## **Service Bulletin**

### **440 Cab updates**

**Bulletin No:** JC-15-05

**Product Type:** STEINER 440 CABS

**Figure 1**

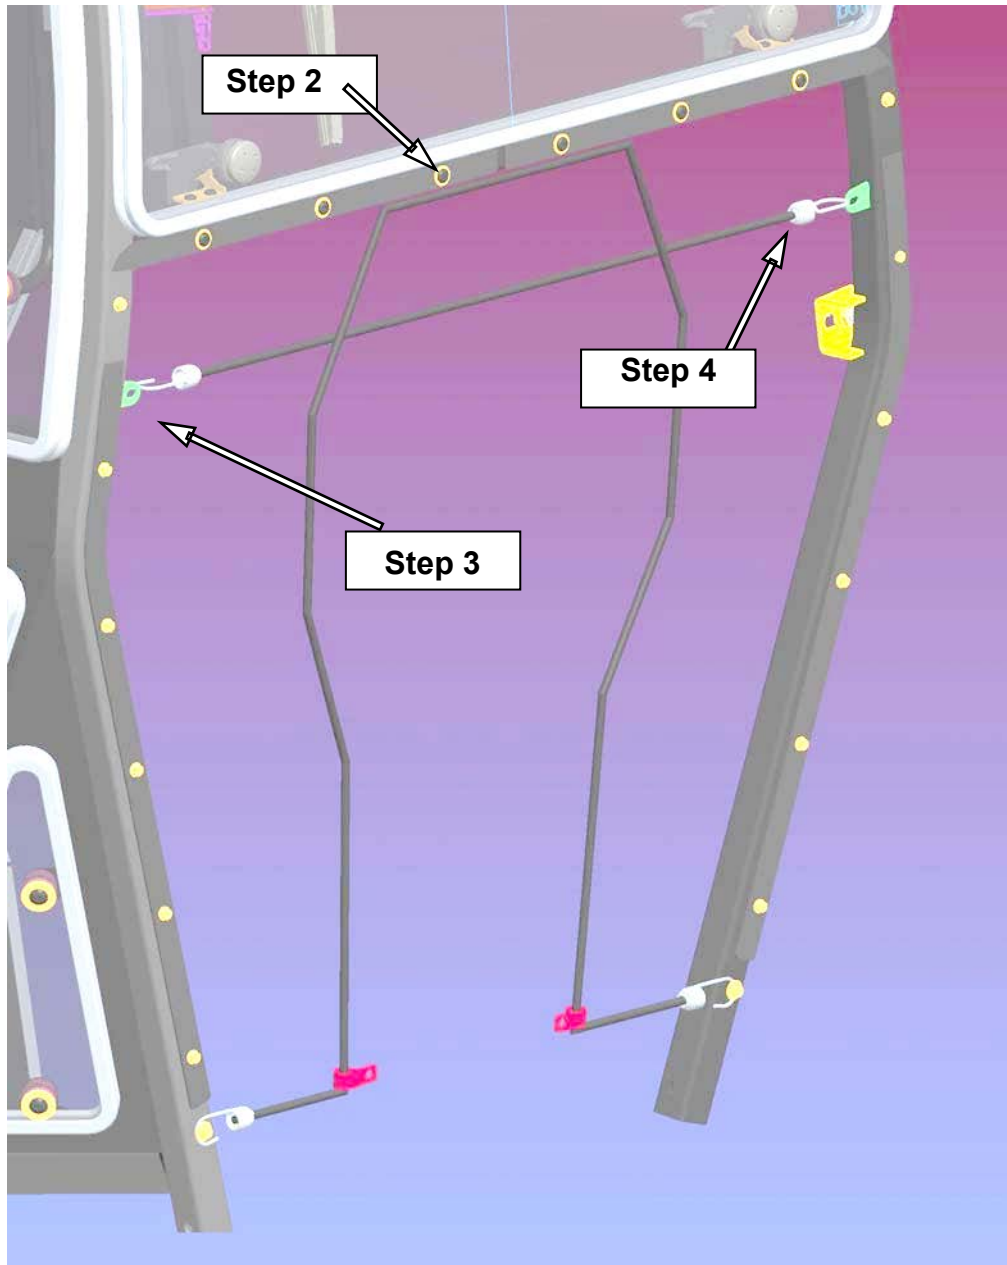
1. Remove the existing lower front panels. Save the hardware, “P” clamps and trim strips.
2. Install the new panels. Install the upper cross panel against the cab cross member followed by the side-panels and trim strips. Install (6) screws into the cross member. **(Figure 1)**
3. Place the left and right bungee cord brackets under the side panels and against the front cab tubes. The brackets are installed with the tab angled into the cab. Reinstall the screws into the cab tubes.

4. Install the short bungee cord onto the (2) bungee bracket tabs. **(Figure 1).**

- A. Order Kit # **970537**-New soft seal kit. (Copy of instructions attached)  
Remove old seal and replace with new seal.  
Note: The stretch cord mounts a different way in the new kit.

**Figure 3**

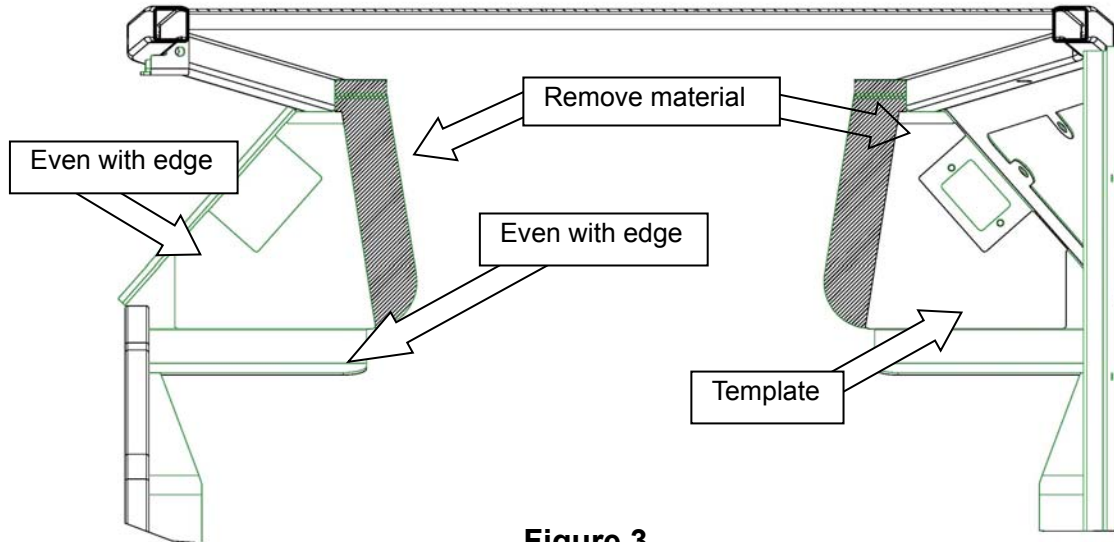
11. Completely remove the foot panel from the machine (**Figure 1**).
12. Use the foot panel template (**Item 2**) to trim the lower foot panels on the cab. This will allow removal of the machine foot plate without removing the cab (**Figure 3**).

B.&C Order kit # **970538**-New mounting bracket kit. (Copy of instructions attached)  
This allows you to remove the foot plate, without removing the cab.

**Figure 5**

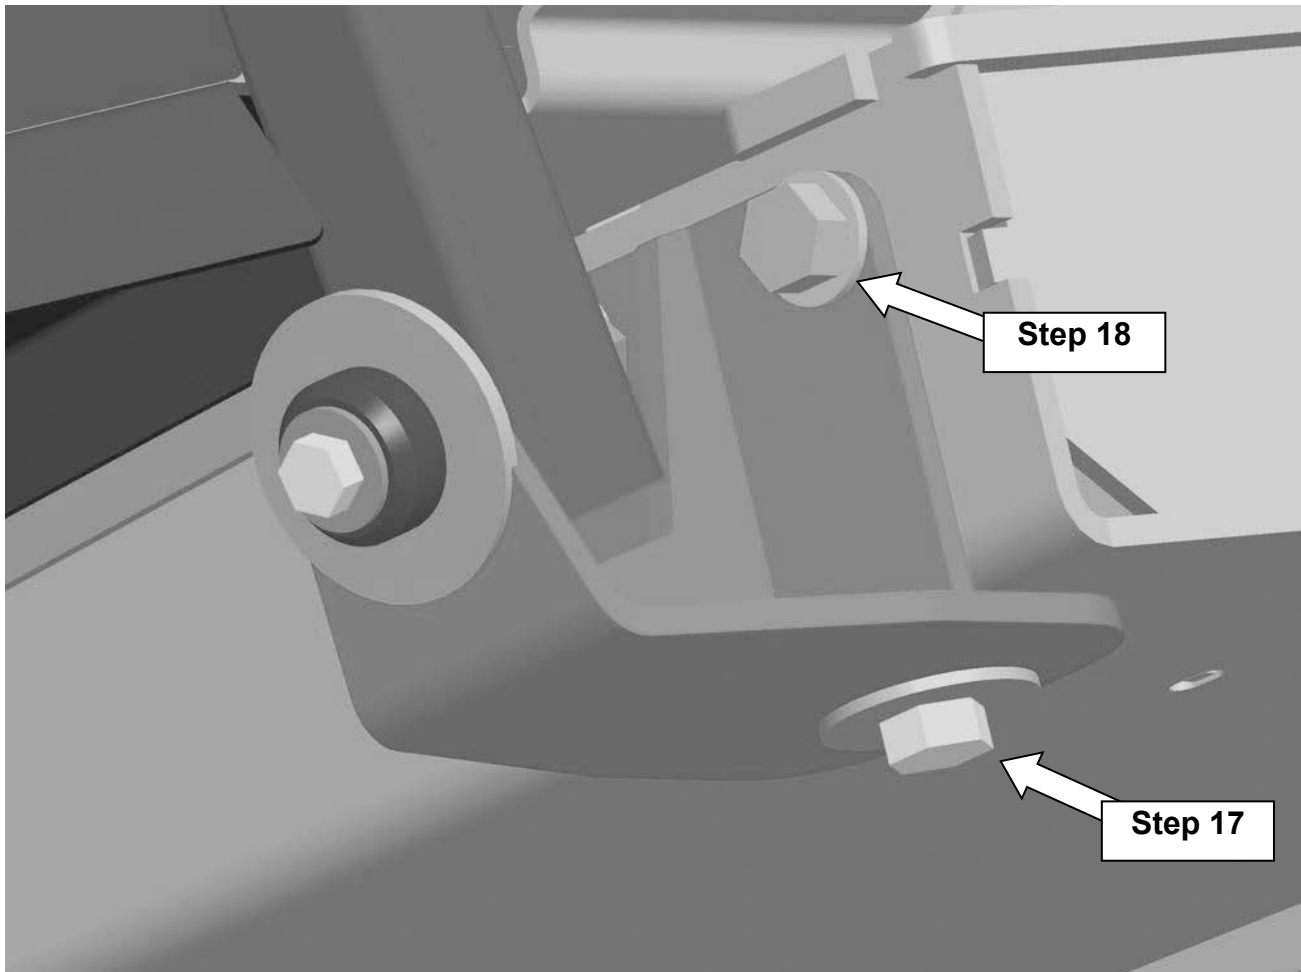
16. Secure the (2) new front mount brackets to the bottom and sides of the machine. **(Figures 4 & 5)**

17. Use the following hardware to secure the brackets to the bottom of the machine. Use the existing hole in the frame.

- **3/8" hardware to 30 FT-LB (41 N-M)**

- **1/2" hardware to 70 FT-LB (95 N-M)**

**Figure 6**

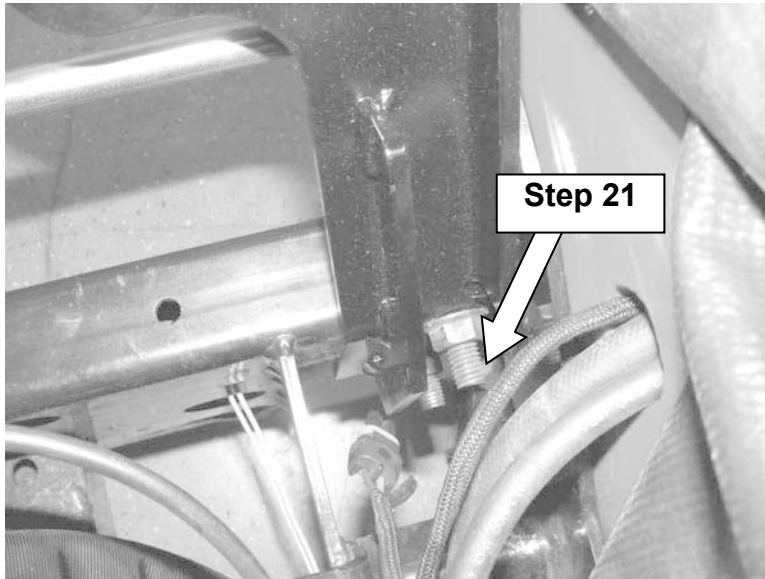
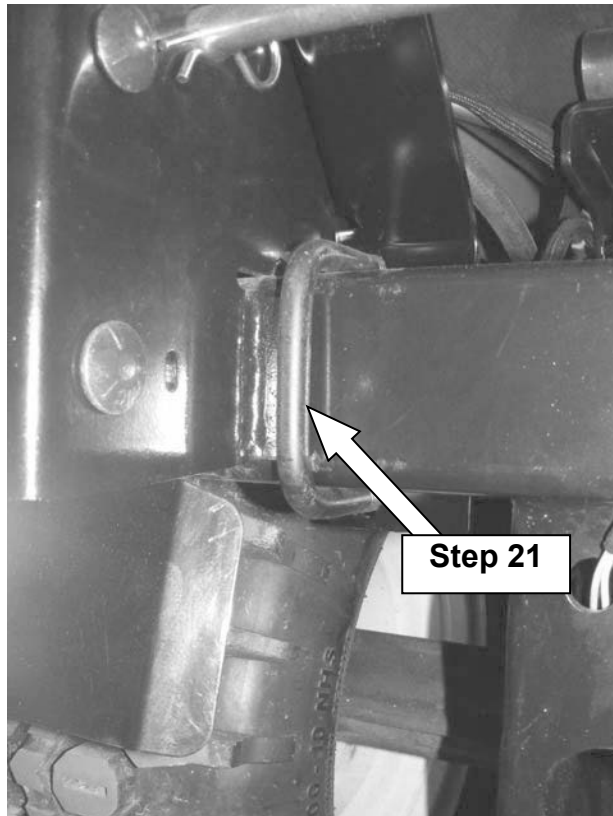
21. Loosely secure the new rear mounting bracket (Item 4) to the machine using (Figures 6 & 7);  
(2) 1/2" U-bolts (Item 14)  
(4) 1/2" serrated flange nuts (Item 10)

**Figure 10**

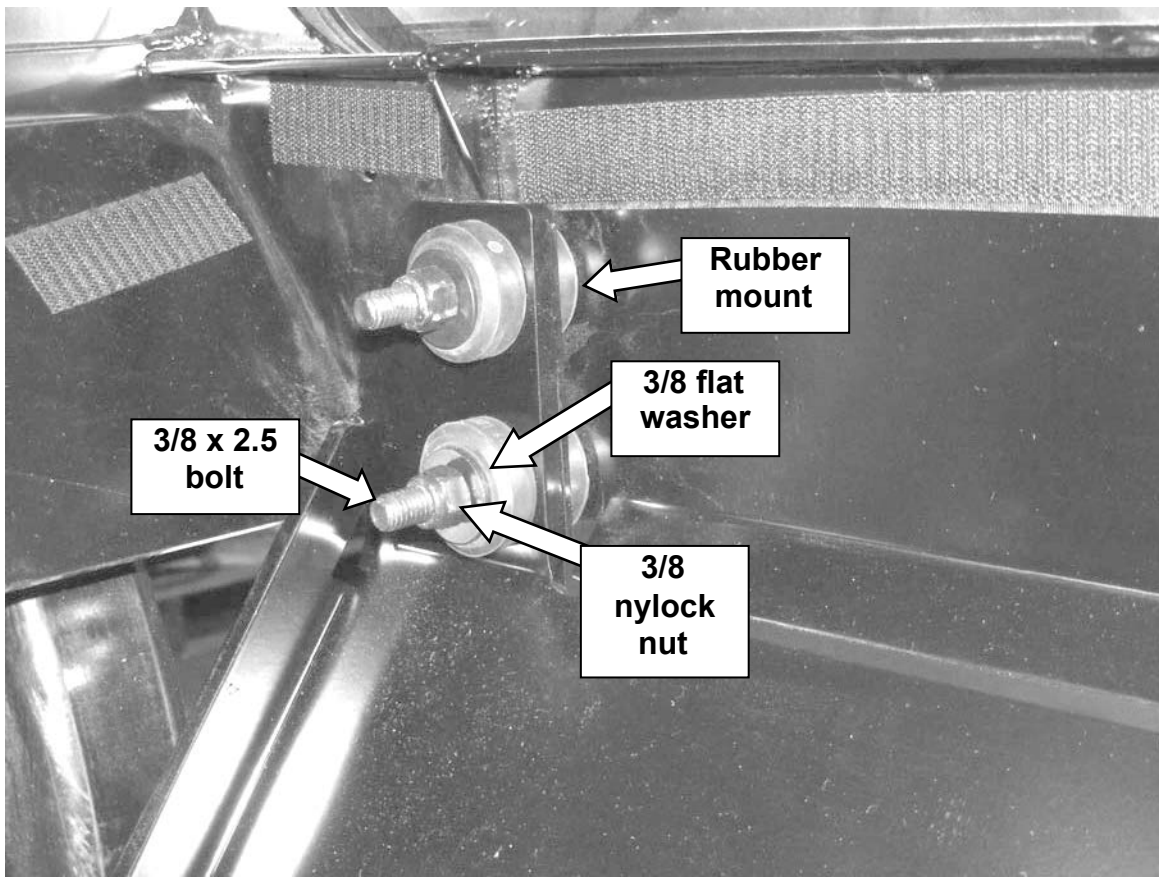
24. Install the rubber isolators (4) onto the rear mount bracket (**Figure 10**). Secure the rear mounting bracket to the back of cab using the hardware removed earlier (**Figure 10**);
